<b>Applicant:</b> Cedar Grove Compost Co	<b>NOC Number:</b> 11573
<b>Project Location:</b> 17825 Cedar Grove Rd, Maple Valley, WA 98038	<b>Registration Number:</b> 25994
<b>Applicant Name and Phone:</b> Ron Westmoreland (206) 450-6182	<b>NAICS:</b> 325314
<b>Engineer:</b> Madeline McFerran	<b>Inspector:</b> Corina Frost

Cedar Grove Composting Inc (Cedar Grove) is an existing commercial composting facility located in Maple Valley, WA. Cedar Grove has an existing Order of Approval (OA) 10645 which covers: the primary and secondary phases of aerated static pile (ASP) composting, the biofiltration systems treating the exhaust air from the primary and secondary ASP phases, an enclosed compost pad for yard waste and commercial food waste (Zone 7), and associated biofiltration control, In-Vessel Gore Cover Technology composting system, a tipping building with associated biofiltration control, a grinding building with associated biofiltration control, and water condensate treatment and holding tank. NOC application 11573 requests modifications to OA 10645.

This Notice of Construction (NOC) Application 11573 includes 6 specific items for review, which are grouped in three categories:

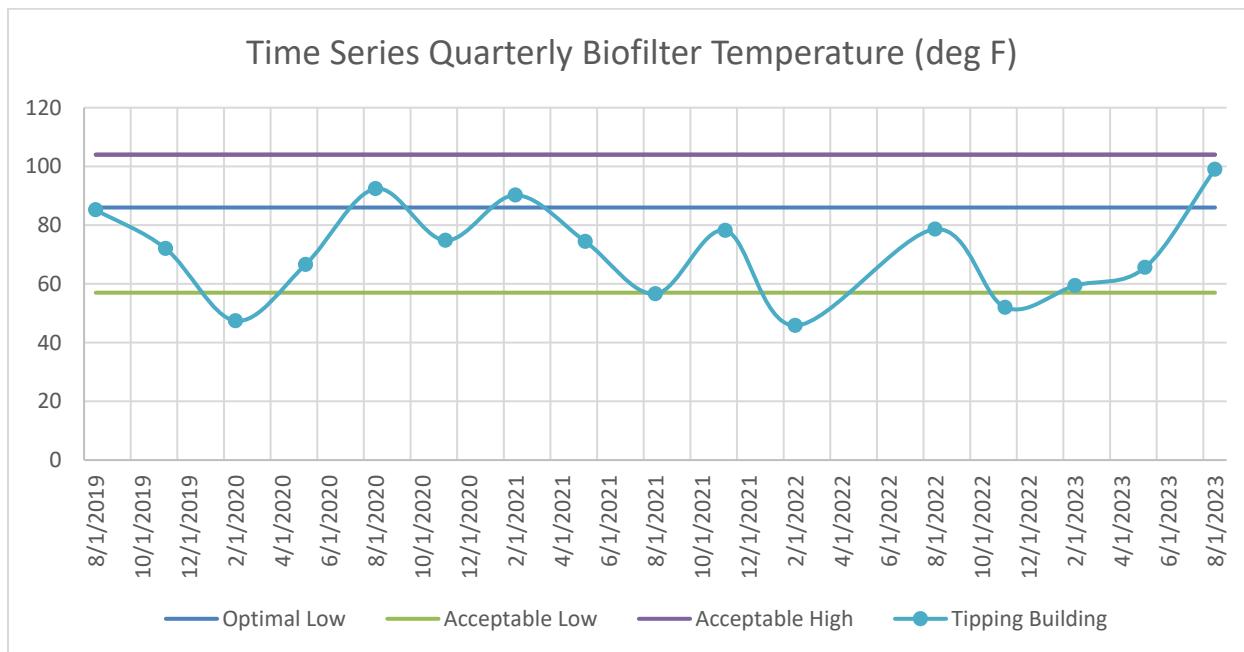
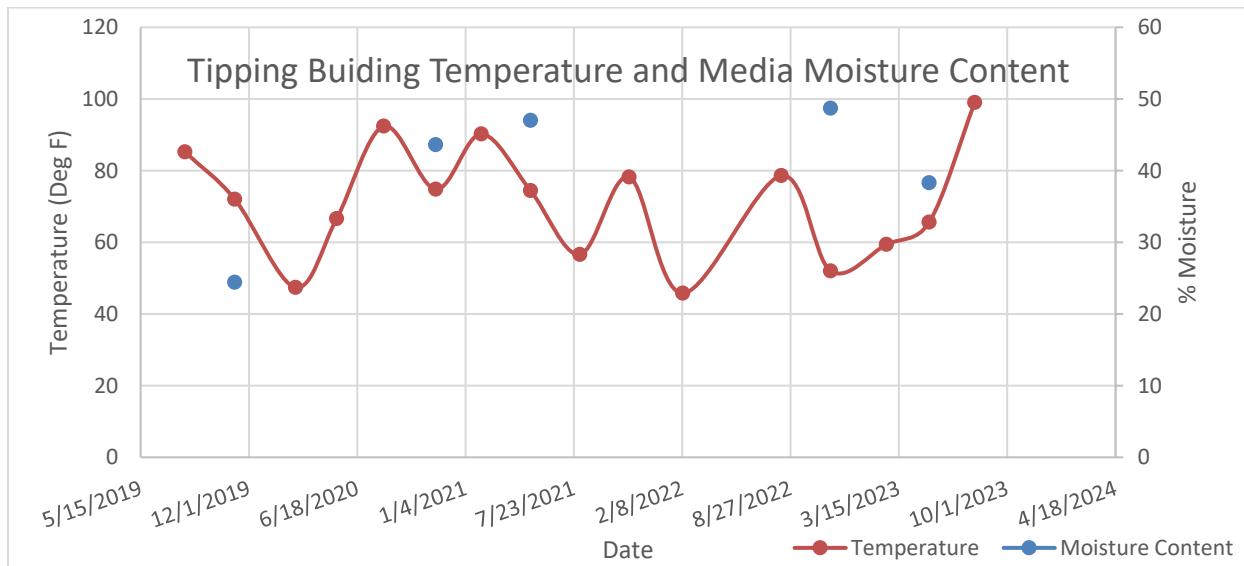
Review of the continuous temperature data for the tipping building shows some seasonal variation in temperature for the biofilter, which is also reflected in the temperatures taken during quarterly 3<sup>rd</sup> party

The temperature trend reflects that much of the tipping building biofilter air is ambient air rather than exhaust off active compost, with temperatures dipping below 68 degrees F typically seen during quarterly evaluations in winter months. The mesophilic bacteria necessary for effective control from the biofilter are active between ~68 and 113 degrees F.

In cases when exhaust air to the biofilter is consistently too cold to maintain media temperature, the biofilter control efficiency may be compromised. The dependence of the exhaust to the biofilter on ambient temperatures seasonally reduces the efficiency of the biofilter serving the tipping building. Continuous monitoring of temperature identifies those situations where the tipping building biofilter falls below the mesophilic zone, however there are limited corrective actions which would address the reduced efficiency of the tipping building seasonally given the configuration of the tipping building. The work practice standards for maximum retention time of stockpiles, or the requirement for biofilter cover on materials remaining stockpiled in the tipping building required for the opening of the bay doors (discussed in Section IV) will supplement odor control during low temperature periods. Based on the results of monitoring and the absence of meaningful corrective action associated with low temperatures, PSCAA has determined that continuous temperature monitoring of the tipping building biofilter is not required moving forward.

#### Continuous Monitoring of Tipping Building Static Pressure

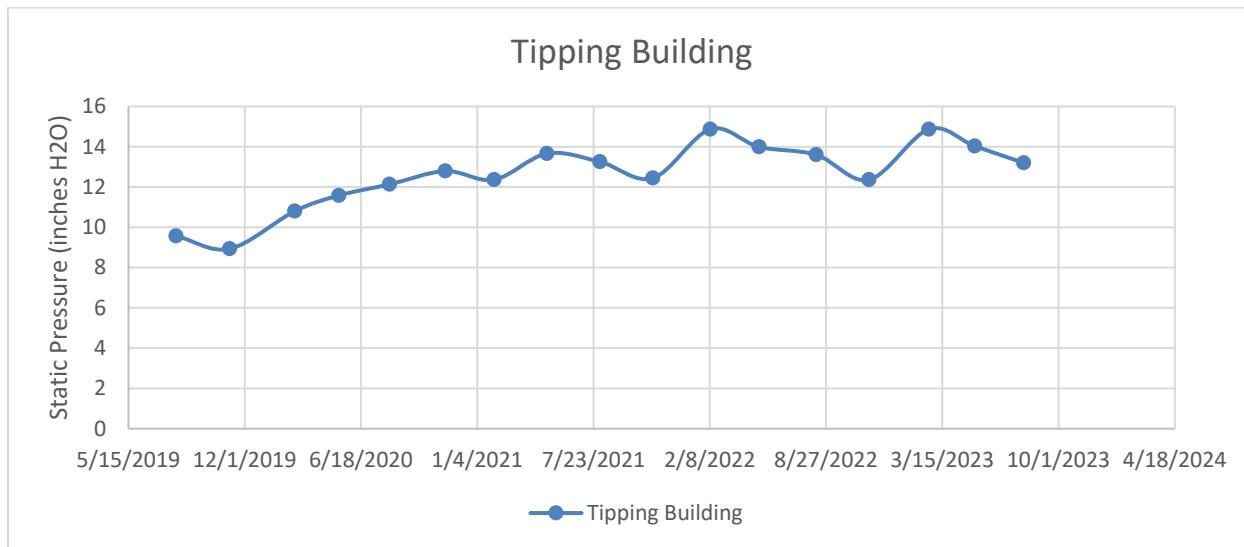
The continuous monitoring of static pressure is not necessary for maintaining the biofilter media; periodic measurements are sufficient for identifying trends in the biofilter media and instigating corrective action (biofilter media replacement). Biofilter static pressure changes associated with media aging occur on time scales captured by less frequent measurement. The static pressure readings from the Tipping Building and Grinding Building during quarterly evaluations from May 2019 through August 2023 are shown below. The time series trend below shows a shift from about 10 inches of water static pressure in 2019Q4 up to about 15 inches of water static pressure in 2022 Q2.

In the case of the tipping building and the grinding building, the static pressure measured in the duct is not solely a measure of the pressure drop across the biofilter. Relative change between readings can be indicative of aging media, particularly when reviewed alongside porosity of media material.

For both the Tipping Building and the Grinding Building, semiannual tracking of the static pressure, rather than continuous measurement will constitute the monitoring of the biofilters to evaluate that they are maintained in good working order, combined with required corrective action to address readings outside of acceptable range.

#### *Continuous Monitoring of Tipping Building Exhaust Flow*

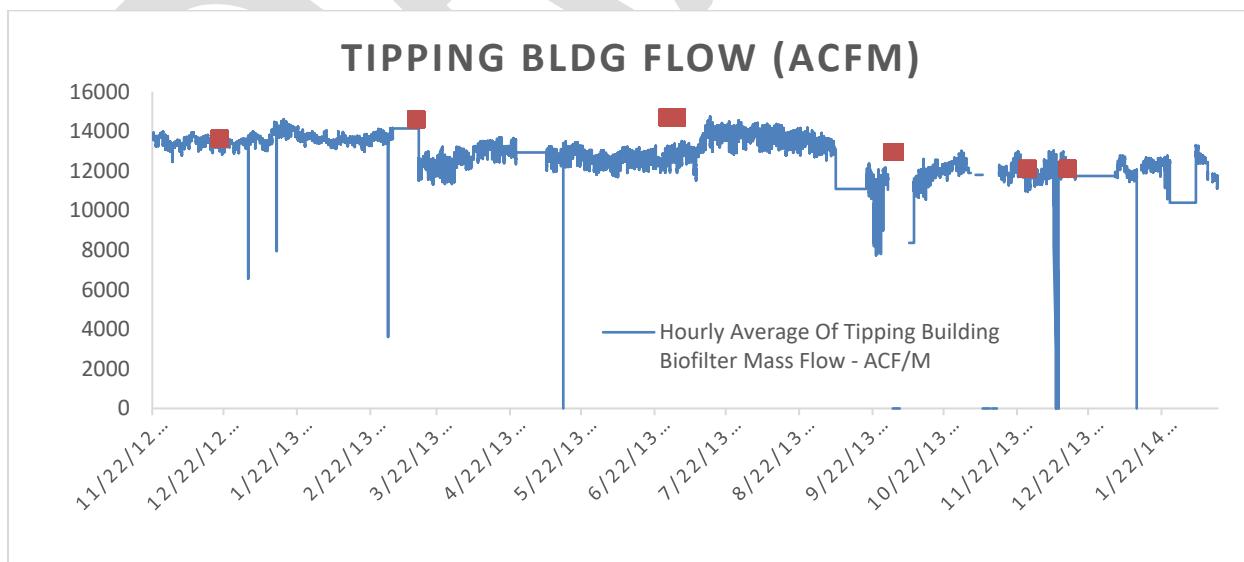
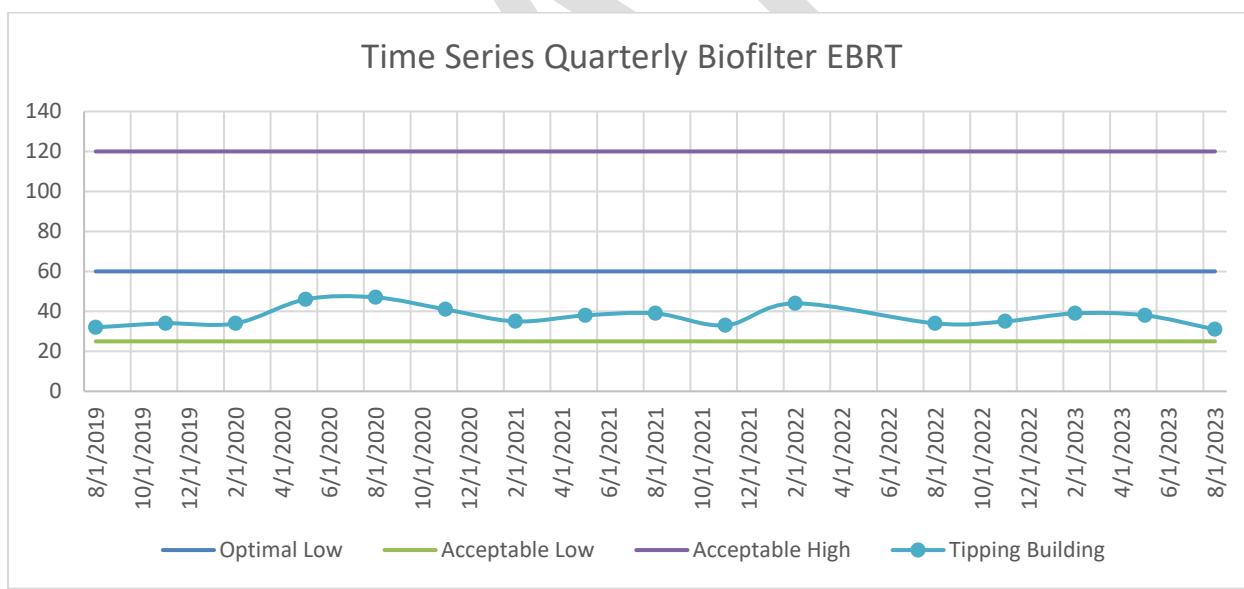
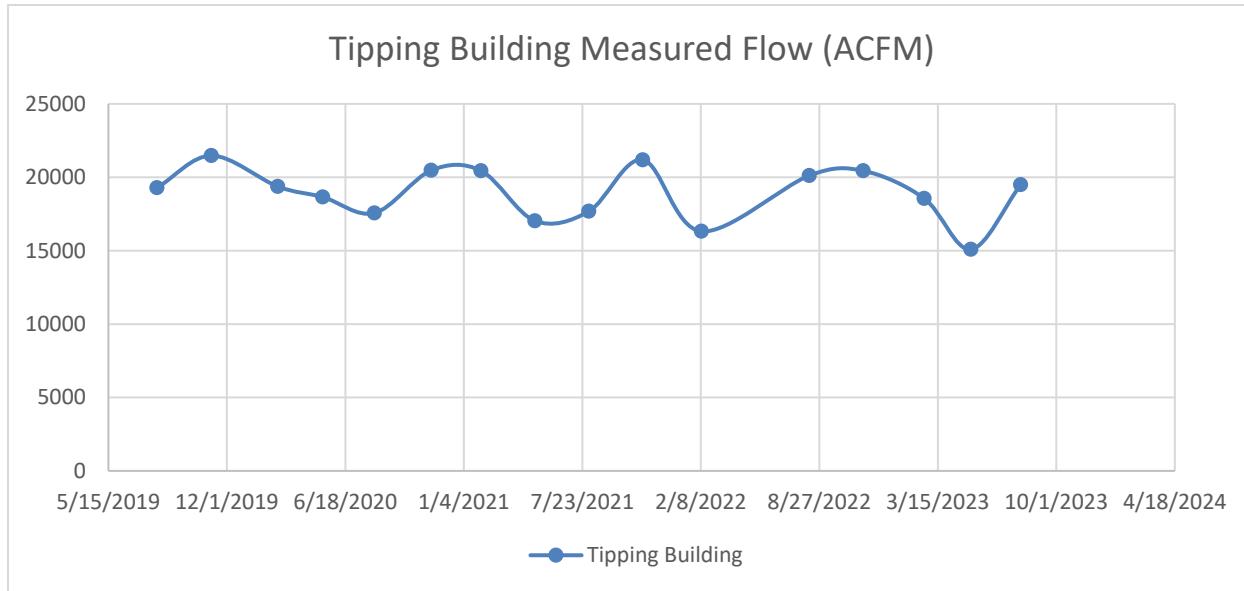
The historic continuous monitoring biofilter exhaust flow data from November 2012 through January 2014 is plotted with the corresponding measurements taken during the third-party quarterly evaluations during that period plotted alongside. Note that the CMS data predates changes in tipping building flow reviewed in NOC 10645 so total flows are lower than those seen in the quarterly evaluations plotted from August 2019 – August 2023.

Flow measurements taken during the quarterly third party evaluations from August 2019 through August 2023 are also included below, followed by the calculated empty bed residence time.

Ongoing measurement of exhaust flow is not found to be necessary to maintaining the quality of the biofilter but will be taken during semiannual evaluations of the biofilters as a part of evaluating the empty bed residence time, and related to the tipping building, tipping building extension, and grinding building ventilation systems operating as designed. Note that in the above plot, optimal high and acceptable high values identified in the 3<sup>rd</sup> Party evaluation are the same.

#### Continuous Monitoring of Primary Biofilter Temperature

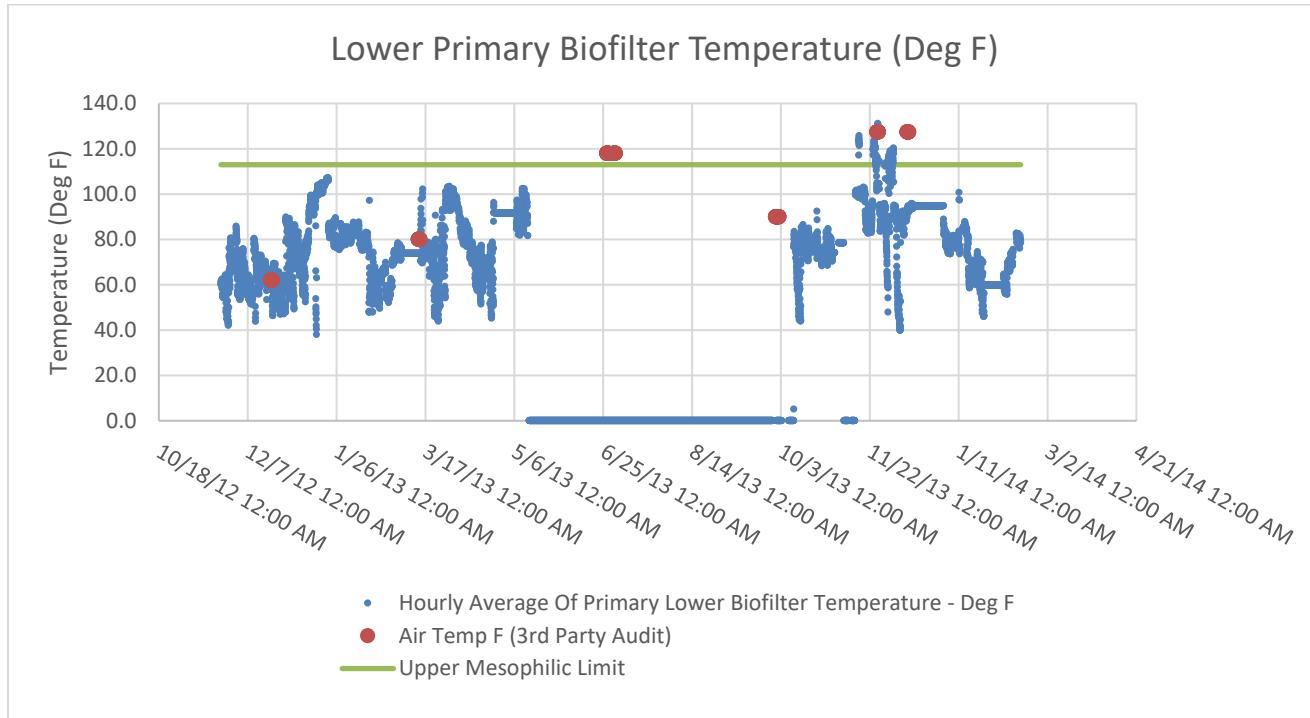
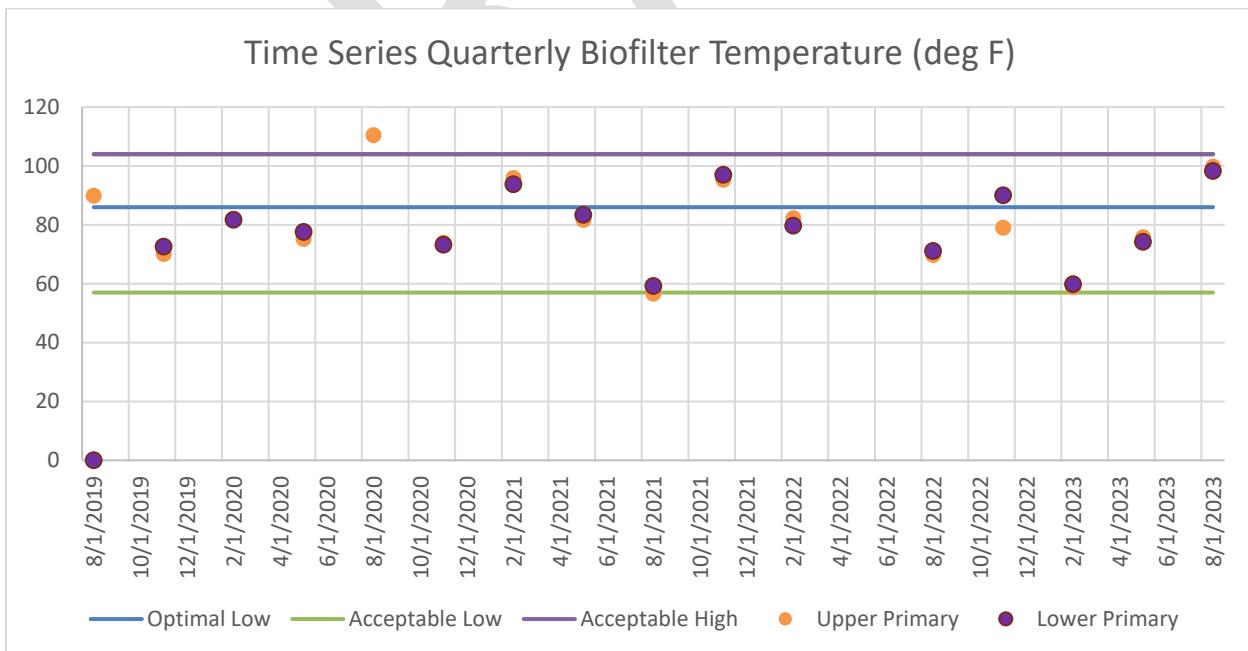
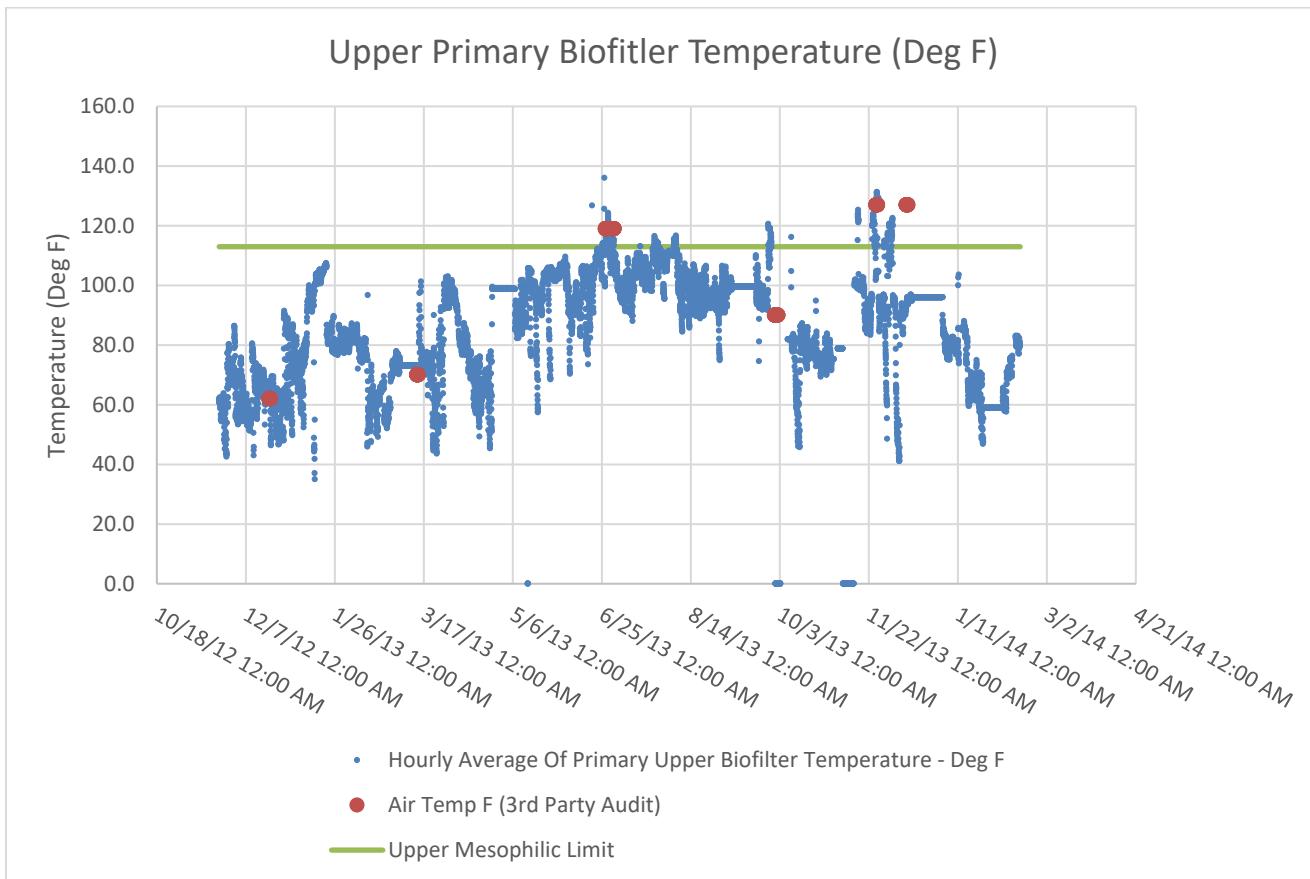
Cedar Grove Maple Valley was required to collect continuous data on the temperature of the upper primary biofilter and the lower primary biofilter. The data from November 2012 through January 2014 are plotted below with the corresponding temperature data from the quarterly 3<sup>rd</sup> party biofilter evaluations plotted. The upper mesophilic limit identified in the Composting Handbook is also plotted for reference.

Continuous monitoring data shows biofilter temperature varying on an hourly time scale, with temperatures exceeding 110 degrees F often in the mid-day to afternoon period. The facility can adjust exhaust flow to introduce more fresh air to bring the temperature back into the mesophilic zone based on the readings of the continuous monitoring system. The upper and lower primary biofilters are handling the exhaust flow from the site's ASPs which can reach temperatures exceeding 150-170 degrees F during thermophilic phase. Given the short-term variation in temperature of exhaust routed to the biofilters, the available methods of corrective action and the impact of those temperature changes on maintaining mesophilic environment, the upper primary and lower primary biofilters will need to maintain temperature monitoring.

#### *Continuous Monitoring of Primary Biofilter Flow*

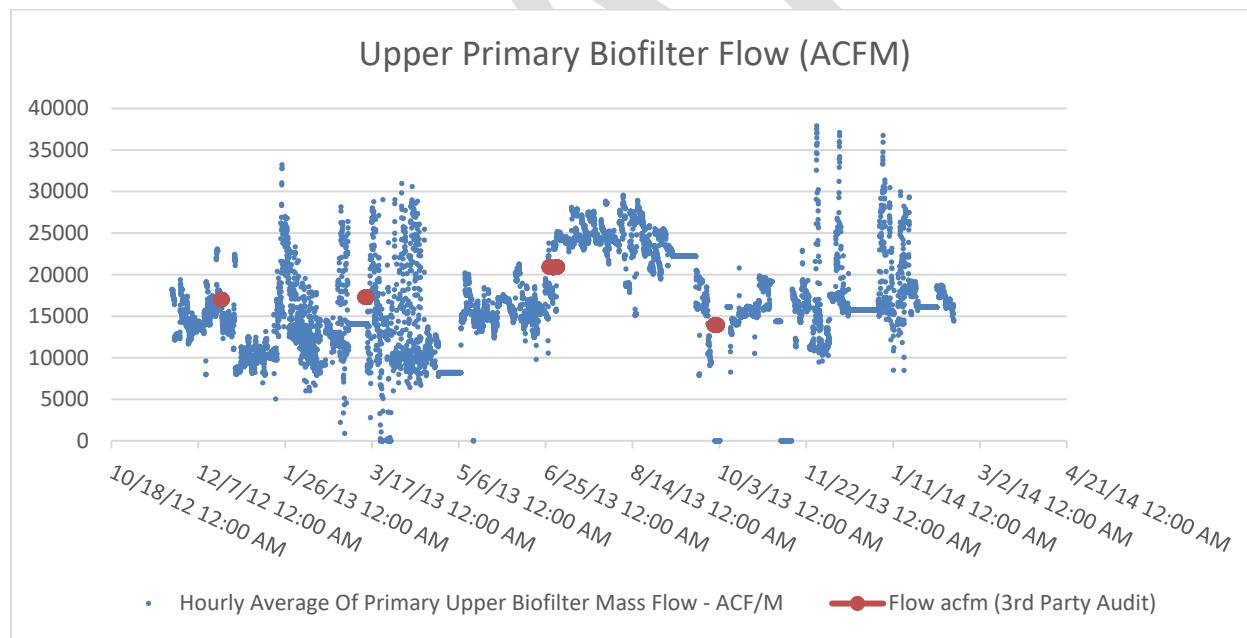
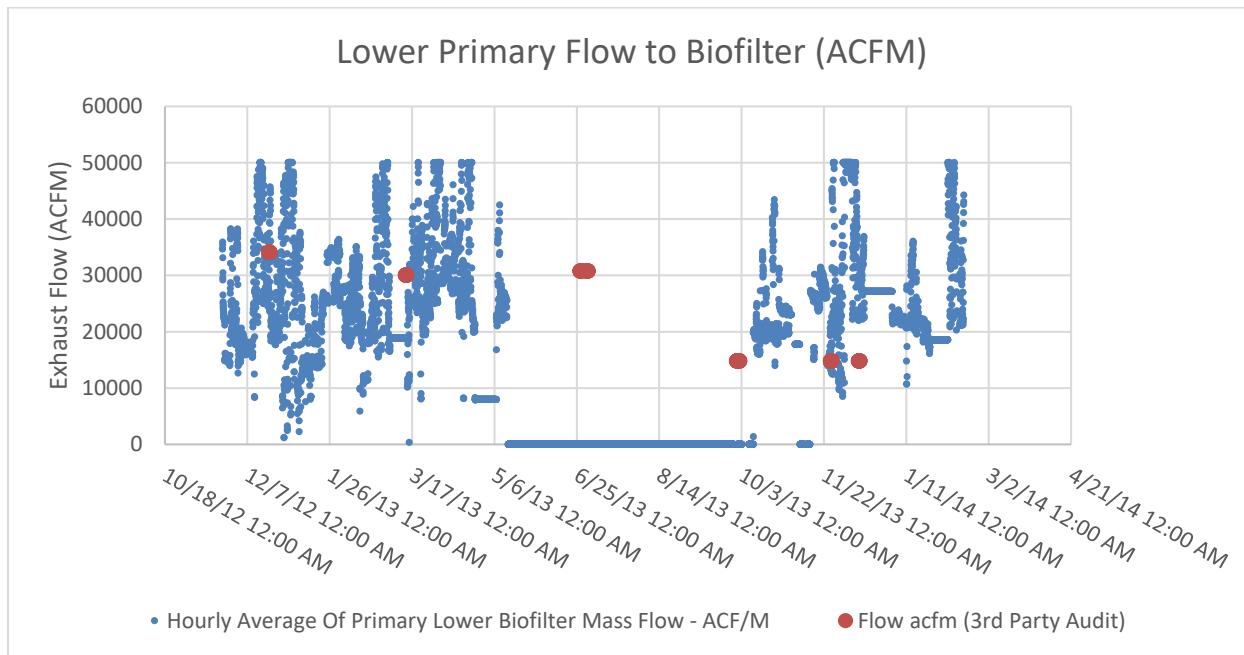
The historic continuous monitoring biofilter exhaust flow data from November 2012 through January 2014 is plotted with the corresponding measurements taken during the third-party quarterly evaluations during that period plotted alongside.

Tracking of the exhaust flow to the biofilter relates to the residence time in the biofilter and relates to the ventilation system fan settings as well as the status of which portions of the 6 zone primary ASP system are actively composting. Given the variability in flow associated with operations (e.g. adjusting ambient air fans to the ASPs for temperature control) and contingent on the periodic checks on biofilter residence time required during 3<sup>rd</sup> party evaluations discussed in Section III.B, PSCAA has determined that continuous flow monitoring on the primary biofilters will not be required moving forward.

Flows will be collected during third-party evaluations.
